# Access Compliance Report

## Public Rights-of-Way

Intersection ID: 8746	Main Street: GENERAL_COMMERCE_DR	Cross Street: INDUSTRIAL_CENTER_CR	Location: S
ADA ID: 7D9A0AD47F52	Ramp Type: Perp	Initial Pass/Fail: Fail	Overall Compliance: No
Severity Score: 12.5			
Codes/Mitigation Info/Possible Solution		Field Measurements/Component Compliance

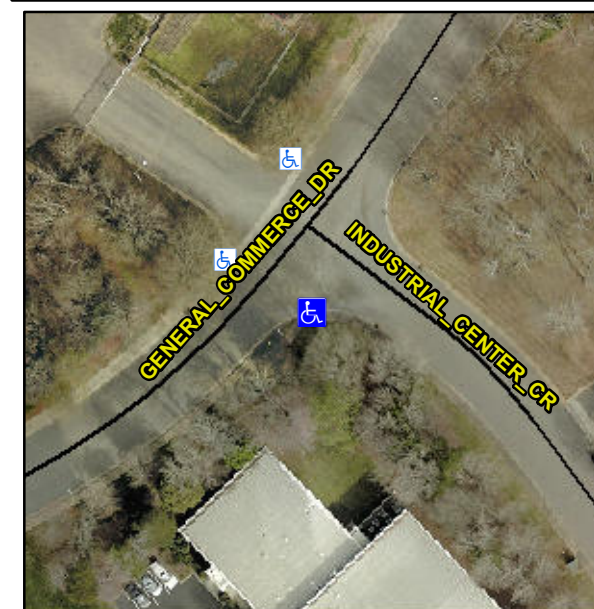
Compliance	Description	Data	Compliance	Description	Data
N/A	Ramp Length (in)	47.5	No	Ramp Slope (%)	10.5
Yes	Ramp Width (in)	52.0	Yes	Ramp XSlope (%)	0.6
N/A	Flare Type LT	N/A	N/A	Flare Type RT	N/A
N/A	Flare Slope LT (%)	N/A	N/A	Flare Slope RT (%)	N/A
N/A	Flare Traversable LT?	N/A	N/A	Flare Traversable RT?	N/A
N/A	Landing Length (in)	N/A	N/A	DWS Provided?	N/A
N/A	Landing Width (in)	N/A	N/A	DWS Contrast?	N/A
N/A	Landing Slope (%)	N/A	N/A	DWS Length (in)	N/A
N/A	Landing X Slope (%)	N/A	N/A	DWS Full Width?	N/A
N/A	Landing Curb? (Y/N)	N/A	N/A	DWS Offset (in)	N/A
N/A	Shared Landing?	N/A			
N/A	Gutter Ponding?	N/A	N/A	Gutter Slope (%)	N/A
N/A	Gutter Lip Ht (in)	1.0	N/A	Gutter X Slope (%)	N/A
N/A	Painted X Walk1?	No	N/A	Painted X Walk2?	N/A
	X Walk 1 Direction	To NW		X Walk 2 Direction	N/A
N/A	X Walk 1 Width (in)	N/A	N/A	X Walk 2 Width (in)	N/A
	X Walk 1 Slope (%)	2.8		X Walk 2 Slope (%)	N/A
	X Walk 1 X Slope (%)	1.8		X Walk 2 X Slope (%)	N/A

**Remove & Replace Entire Ramp.**
